Access Compliance Report

Public Rights-of-Way

Intersection ID: 12347	Main Street: S_CHURCH_ST	Cross Street: W_3RD_ST	Location: S
ADA ID: E36AACA05164	Ramp Type: Perp	Initial Pass/Fail: Fail	Overall Compliance: No
		Severity Score: 12.5

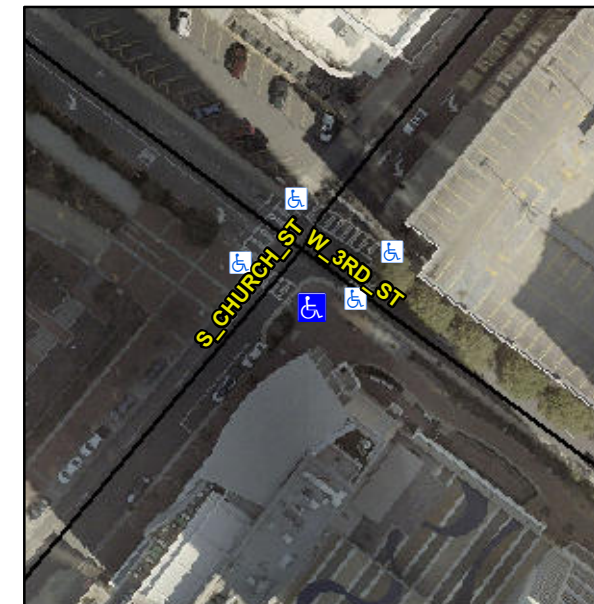
Not Found, R304.2.2

Compliance	Description	Data	Compliance	Description	Data
N/A	Ramp Length (in)	47.0	No	Ramp Slope (%)	8.7
Yes	Ramp Width (in)	48.0	Yes	Ramp XSlope (%)	1.8
N/A	Flare Type LT	N/A	N/A	Flare Type RT	N/A
N/A	Flare Slope LT (%)	N/A	N/A	Flare Slope RT (%)	N/A
N/A	Flare Traversable LT?	N/A	N/A	Flare Traversable RT?	N/A
N/A	Landing Length (in)	N/A	N/A	DWS Provided?	N/A
N/A	Landing Width (in)	N/A	N/A	DWS Contrast?	N/A
N/A	Landing Slope (%)	N/A	N/A	DWS Length (in)	N/A
N/A	Landing X Slope (%)	N/A	N/A	DWS Full Width?	N/A
N/A	Landing Curb? (Y/N)	N/A	N/A	DWS Offset (in)	N/A
N/A	Shared Landing?	N/A			
N/A	Gutter Ponding?	N/A	N/A	Gutter Slope (%)	N/A
N/A	Gutter Lip Ht (in)	N/A	N/A	Gutter X Slope (%)	N/A
N/A	Painted X Walk1?	Yes	N/A	Painted X Walk2?	N/A
	X Walk 1 Direction	To NW		X Walk 2 Direction	N/A
N/A	X Walk 1 Width (in)	111.0	N/A	X Walk 2 Width (in)	N/A
	X Walk 1 Slope (%)	1.3		X Walk 2 Slope (%)	N/A
	X Walk 1 X Slope (%)	1.7		X Walk 2 X Slope (%)	N/A

Remove & Replace Entire Ramp.
